PRODUCT / PROCESS CHANGE NOTIFICATION

1.1 Company	 STMicroelectronics International N.V
1.2 PCN No.	EMBEDDED PROCESSING/26/16266
1.3 Title of PCN	HTXA (China) additional UFQFPN5x5 32L and UFQFPN7x7 48L package assembly line for STM32G03x/G04x, STM32G05x/G07x and STM32G08x listed products
1.4 Product Category	STM32G031x, STM32G041x, STM32G051x, STM32G071x and STM32G081x.
1.5 Issue date	2026-07-15

PCN16266 – Additional information

HTXA (China) additional UFQFPN5x5 32L and UFQFPN7x7 48L package assembly line for STM32G03x/G04x, STM32G05x/G07x and STM32G08x listed products

Table 1

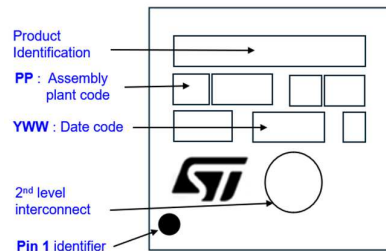
Introduction of an additional assembly line to continue our path through the deployment of our Low-cost wire strategy to secure our supply chain.

UFQFPN5x5 32L UFQFPN7x7 48L		Existing back-end assembly line				New assembly line
Assembly site		ST Calamba (Philippines)	ASE KaoHsiung (Taiwan)	StatsChipPAC JSCC Jiangyin (China)		HTXA (China)
Die Attach		LOCTITE ABLESTIK QMI519	EN4900G	Ablebond 8290	EN4900GC	
Molding compound ⁽¹⁾		9240ZHF10 W	Sumitomo EME-G631H	Sumitomo G770	Sumitomo G700LALA	Sumitomo G631BQ
Wire bonding		CuA 2N 0.8Mils	Gold 4N 0.8Mils	CuPd 0.8Mils	Gold 3N 0.8Mils	CuPd 0.8Mils
Lead frame		Copper, pre-plated	Copper, post-plated			
Leadfinishing ⁽²⁾		NiPdAu (e4)	PureTin (e3)

(1) Package darkness might change depending on molding compound. Visual aspect (color) might change depending on substrate material. Marking position and size could be different upon assembly site, without any loss of information.

(2) Lead color and surface finish change depending on leadfinishing.

for **UFQFPN 48L 7x7** package

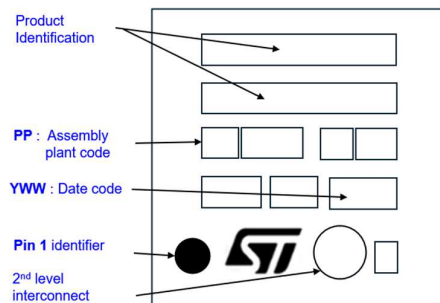
Pin1 identifier may change in terms of size and positioning however remaining near pin1's edge.
Marking position and size may be different upon assembly site, without any loss of information.
